**RE: MVC Draft Amendment 4/2020 - Meander Valley Council submission in response to TPC post hearing direction of 23 December 2021.**

## **Draft Amendment 4/2020**

**100 Country Club Avenue, Prospect Vale**

### **Meander Valley Council Submission to TPC Direction 23 December 2021**

*Figure 8: Recommended modification of the draft amendment to include an extension of the internal road network to connect with the future junction of Mt Leslie Road and Pitcher Parade.*

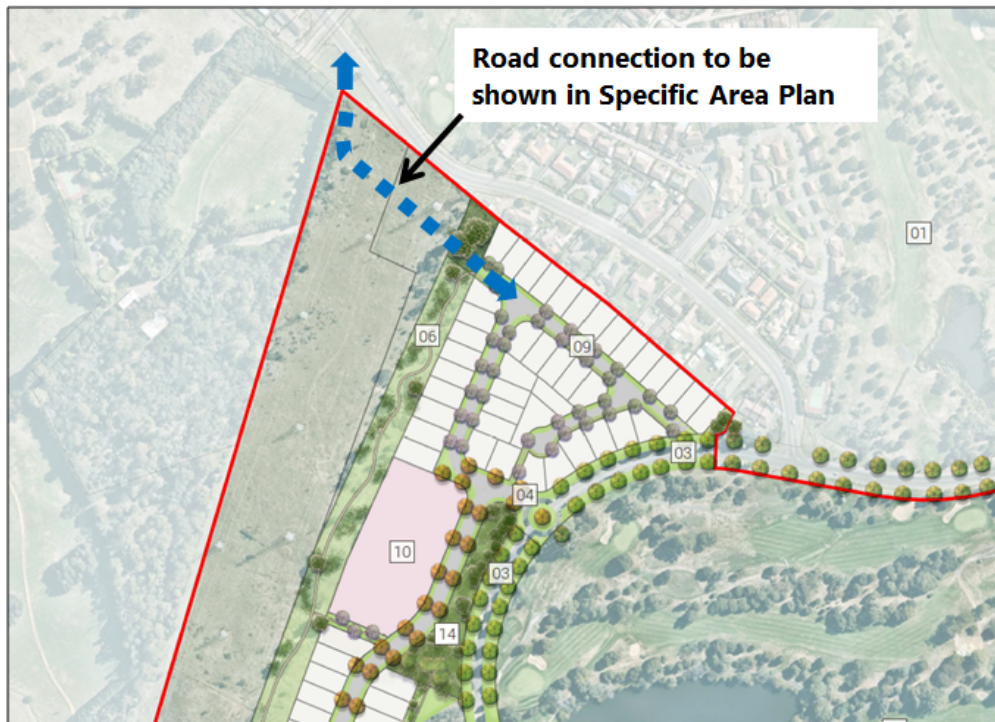
*In order to further the Structure Plan Strategies for the road network and traffic, it is recommended that the draft amendment is modified to include an extension of the internal road network, through to Pitcher Parade at the north west boundary corner as shown in Figure 8 below, to connect with the future junction of Mt Leslie Road with Pitcher Parade. Figure 9 shows the corresponding modification to the submitted Specific Area Plan map.*

**New Figure S23.1 – Building envelope for the Apartment Living Site**

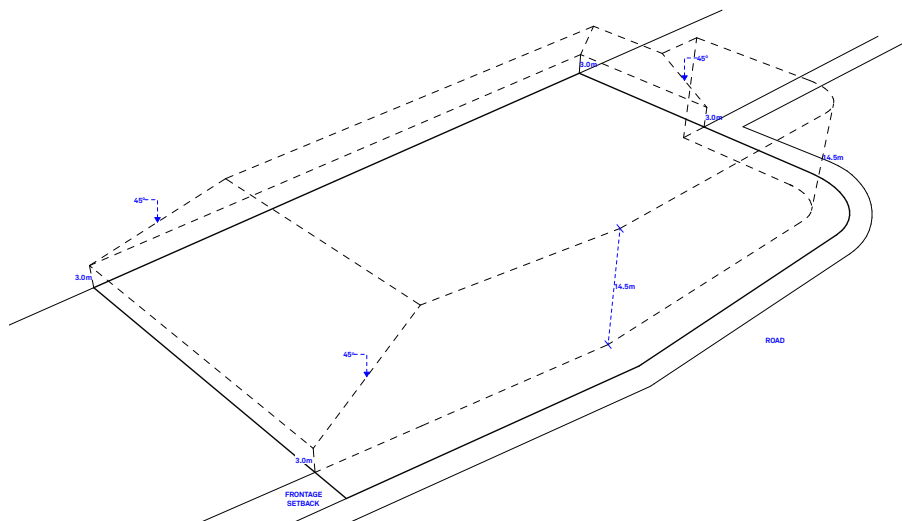
4. *In regard to the structure of the SAP, inclusion of a building envelope diagram relating to clause S23.7.1, reference to the apartment living site in S23.7.2 and consideration c of any changes to the wording of clause S23.8.1 that would be required to facilitate subdivision in accordance with the development plan. For example, ensuring that all performance criteria elements are relevant to the development plan. Note: regard may also be given to the heading of the clause which is contradictory in that it refers development standards for subdivision.*

The SAP text has been revised to change all references to apartment living to the 'Apartment Living Site'. A building envelope diagram (shown below) for the Apartment Living Site, consistent with the drafting style of the Tasmanian Planning Scheme and inclusive of the frontage setbacks required by the General Residential Zone, has been included at Figure S23.1.

Extract from Landscape Section (Woolcott Surveys L200315 - 13/8/21)

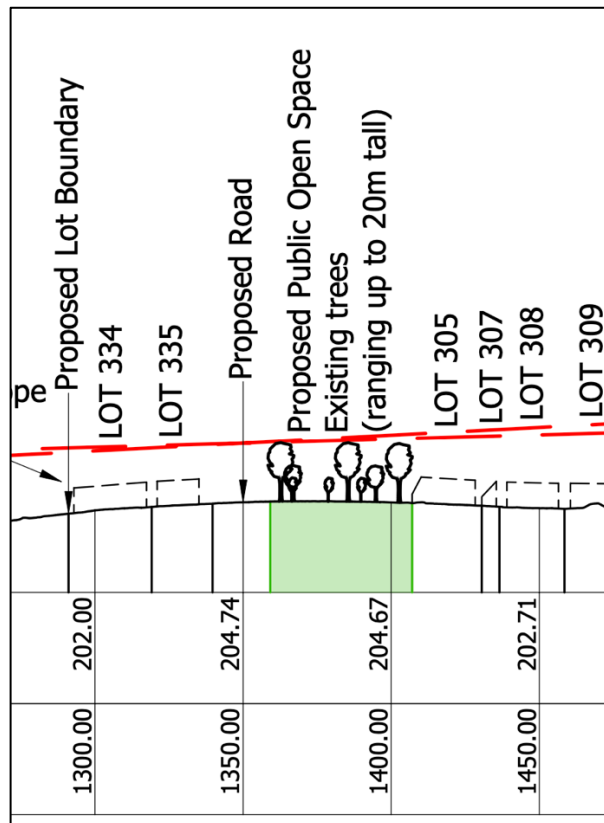
An extract is included below from the landscape section that was exhibited on 14 August 2021 as part of the supplementary notification. The landscape section shows that the public open space is centred around the crest of the central ridgeline which peaks at approximately 205.5 AHD and lowers to approximately 203.0 AHD at either end. Limiting the extent of any change to the 203.0 AHD level ensures that the visual landscape mitigation intent of a vegetated ridgeline is protected.

*(i) public open space over the crest of the central ridgeline with a minimum area of 1.25ha at an elevation not less than 203.0 AHD; and*

As discussed above, these criteria set minimum mandatory standards for the public open space location and size and the future construction of a northern link road through to Pitcher Parade.

Figure S23.2 Development Plan

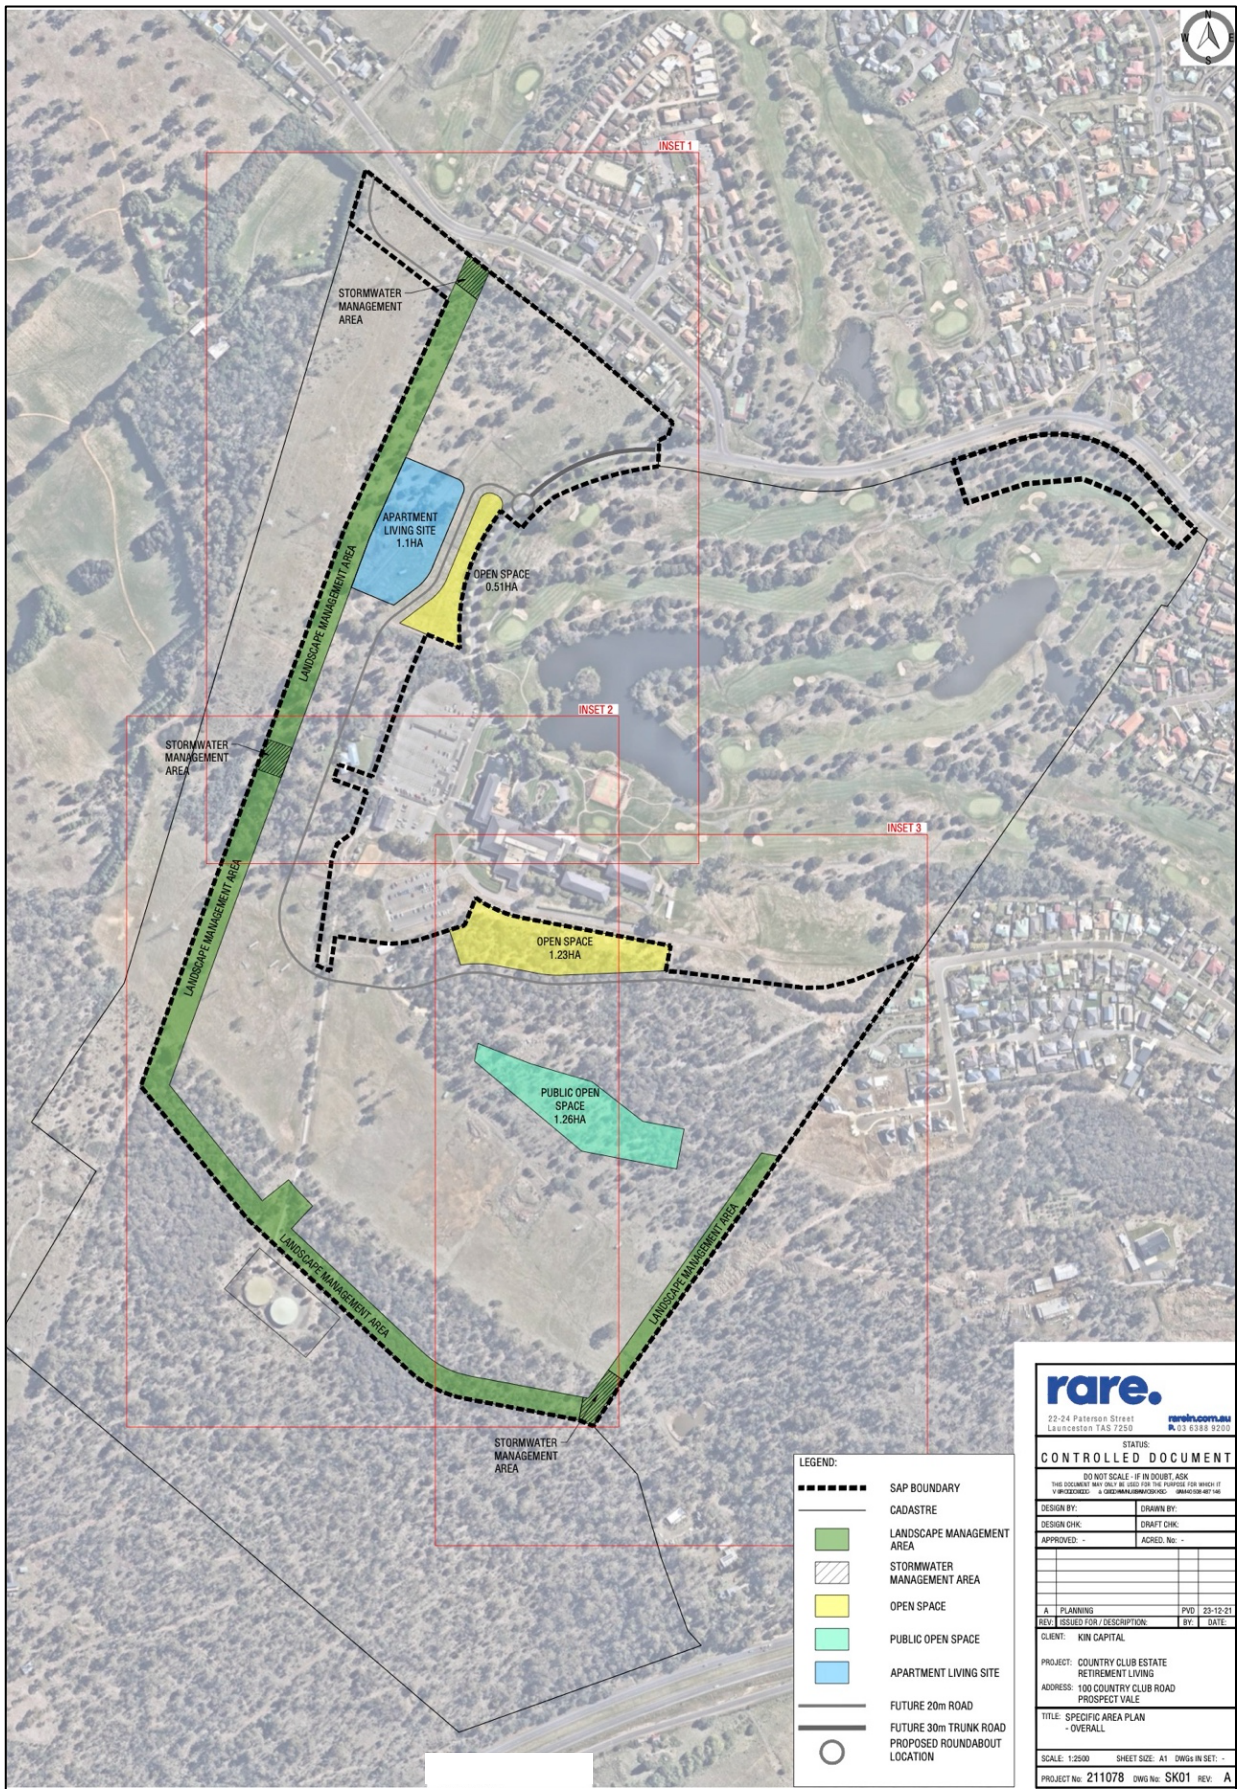
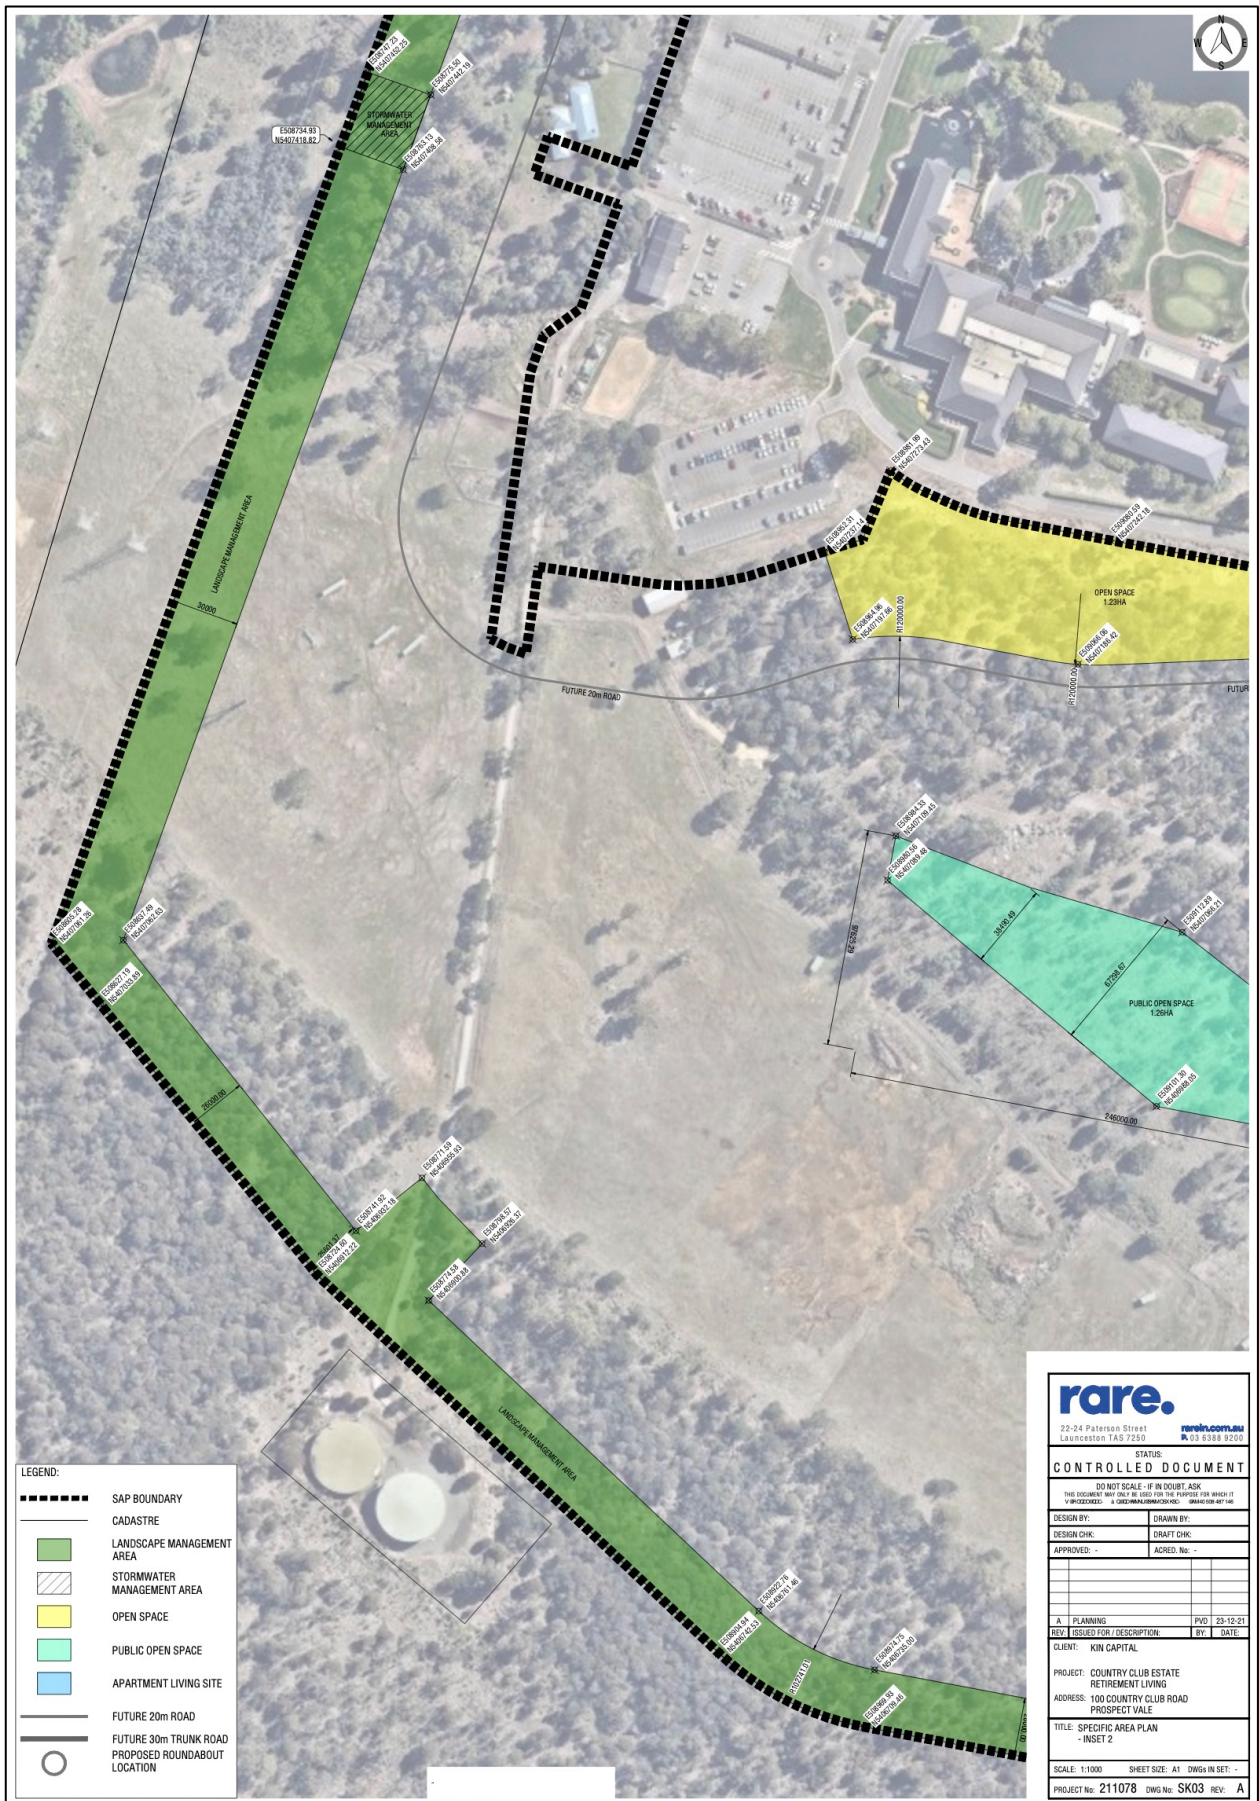
1. *For the bushfire hazard management area shown on the SAP, a submission on how to identify the dimensions in relationship to the SAP and what the bushfire hazard management area may be more appropriately labelled to reflect the proposed use of the land to include walking trails and vegetation management.*

Consistent with discussions in the hearing, the SAP drawing for the development plan has been revised to allow for the provision of sufficient detail to identify the precise locations of the specified areas and the relative dimensions. The areas identified in more detail include:

- the overall plan at a smaller scale showing the relationship of the various parts; and
- three inset drawings (identifiable on the overall plan) at a larger scale showing dimensions from SAP boundaries and coordinate points to enable accurate location of the identified areas on the land.

It is submitted that the peripheral area is renamed to 'Landscape Management Area' reflective of its variable uses for bushfire management, walking trails and visual impact management.

Refer to comments above regarding revision of SAP drawings. Each of the *Open Space* areas and the *Public Open Space* are individually locatable through a combination of coordinates and dimensions.

(f) key stormwater management locations.
Acceptable Solutions	Performance Criteria
<p><b>A1</b></p> <p>Subdivision must be in accordance with the development plan at Figures S23.2 – S23.3.4</p>	<p><b>P1</b></p> <p>Subdivision must be consistent with the purpose of the Specific Area Plan <b>and generally in accordance with the development plan at Figures S23.2 – S23.5</b>, having regard to:</p> <ul style="list-style-type: none"> <li>(a) the topographical or natural features of the site;</li> <li>(b) <b>screening and visual amenity provided by existing vegetation or new plantings at the interface of the Country Club Tasmania complex with the residential area;</b></li> <li>(c) <b>the relative visibility of future development within the landscape;</b></li> <li>(d) any requirements for bushfire hazard management areas;</li> <li>(e) the provision of a hierarchy of local and collector roads <b>and the need to establish connections to the existing and future road network;</b></li> <li>(f) pedestrian connectivity <b>within the development and to the existing and future pedestrian pathway network;</b></li> <li>(g) the need to install infrastructure and services;</li> <li>(h) the ability of the subdivision to provide for housing diversity if the lot for the Apartment Living Site is modified; and</li> <li>(i) <b>must include the public open space in accordance with Figure S23.1:</b> <ul style="list-style-type: none"> <li>(i) <b>public open space over the crest of the central ridgeline with a minimum area of 1.25ha at an elevation not less than 203.0 AHD; and</b></li> <li>(ii) <b>a 20m wide road extending from the residential area through to Pitcher Parade at the northern boundary of the site.</b></li> </ul> </li> </ul>
